SERVICE INFORMATION

NO. SI 20E-016

I.2 Subject

Inspection and/or replacement of expansion tank assy. for ROTAX® 912, 914, 912 i, 915 i and 916 i (Series) Aircraft Engines

Fig. 1

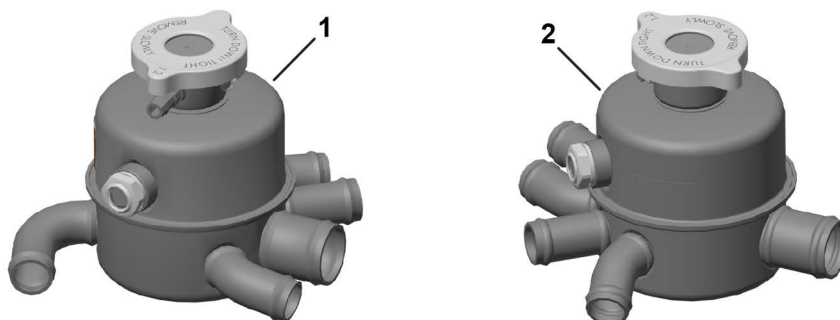
Due to a deviation in the manufacturing process, the individual components of the expansion tank assy. may not be sufficiently welded. Sealing of the assy. may be compromised and coolant leakage and subsequently an overheating of the engine may occur.

Fig.1/ pos.	part no.	Qty/ engine	Description
1	922668	(1)	EXPANSION TANK ASSY.
2	922666	(1)	EXPANSION TANK ASSY.
-	-	AR	COOLANT (as specified in the latest Service Instruction SI-912-016, SI-914-019, SI-912 i-001, SI-915 i-001,SI-916 i-001)

Fig. 3

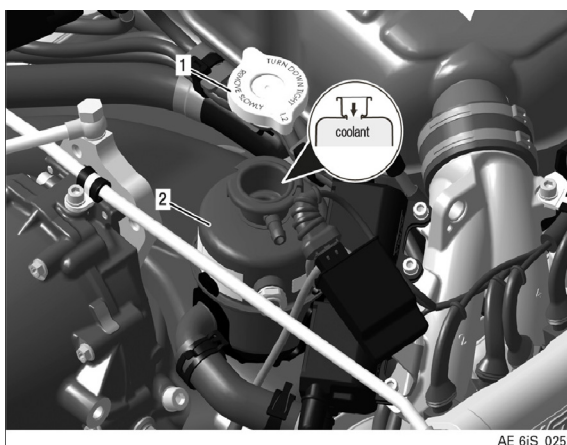
Step	Procedure
1	If necessary, clamp closed the hose to the coolant overflow bottle.
2	Remove the radiator cap from the expansion tank.
3	Drain coolant until bottom of the expansion tank assy. is clearly visible.
4	Perform an internal visual inspection of the expansion tank assy. using a bore-scope or similar optical device.
5	If the visual inspection shows consistent welding, the expansion tank assy. is serviceable (See Fig. 5), continue with step 7.
6	If any connection has inconsistent or missing welds, the expansion tank assy. is unserviceable and must be replaced (See Fig. 6), continue with section 3.5.2).
7	Refill coolant into the expansion tank. See Maintenance Manual Line Chapter 12-10-00 section Coolant check/replenish. See also SI-912 i-001,SI-912-016,SI-914-019, SI-915 i-001,SI-916 i-001, current issue. NOTE: If the engine is equipped with a thermostat valve, follow the manufacturer's instructions.

8	Apply small amount of coolant to rubber surfaces inside radiator cap (provides lubrication to prevent binding). Tighten the radiator cap by hand.
9	Perform an engine test run and check for leaks. Replenish with clean coolant as required. See Maintenance Manual Line Chapter 12-10-00 section Coolant check/replenish.
10	Make an entry in the engine logbook stating the execution of this Service Bulletin and the inspection findings. Continue with section 3.6)

Fig. 5: GOOD Welding – total view / GOOD Welding – side view

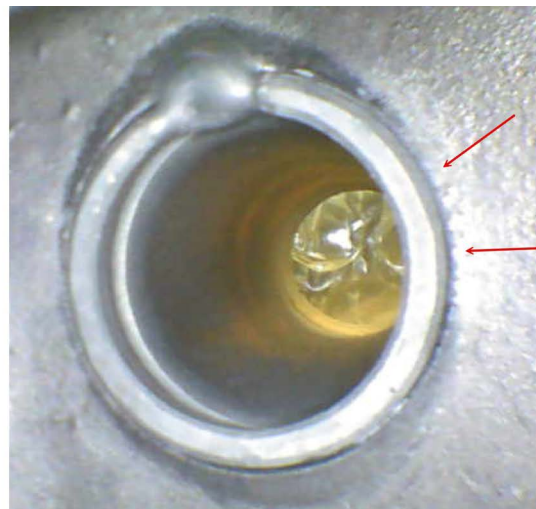
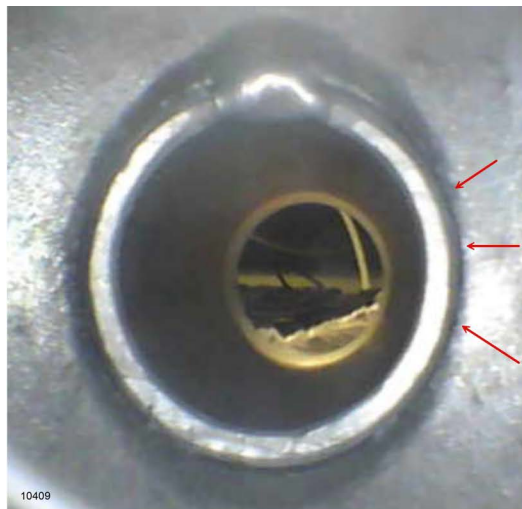
Step	Procedure
1	Remove the radiator cap from the expansion tank.
2	Perform an internal visual inspection using a bore-scope or similar device.
3	If the visual inspection shows consistent welding, the expansion tank assy. is serviceable (See Fig. 5), continue with section 3.6). NOTE: Welding must be present and contiguous around every connection.
4	If the visual inspection shows any connection with inconsistent or missing welds, the expansion tank assy. is unserviceable and must be replaced (See Fig. 6).
5	Apply small amount of coolant to rubber surfaces inside radiator cap (provides lubrication to prevent binding). Tighten the radiator cap by hand.

Step	Procedure
1	If necessary, open the engine box and pull back the protective blue bag.
2	Remove the radiator cap from the expansion tank.
3	Perform an internal visual inspection using a bore-scope or similar device.
4	If the visual inspection shows consistent welding, the expansion tank assy. is serviceable (See Fig. 5). Continue with section 3.6). NOTE: Welding must be present and contiguous around every connection.
5	If the visual inspection shows any connection has inconsistent or missing weld, the expansion tank assy. is unserviceable and must be replaced (See Fig. 6), continue with section 3.5.1).
6	Apply small amount of coolant to rubber surfaces inside radiator cap (provides lubrication to prevent binding). Tighten the radiator cap by hand.
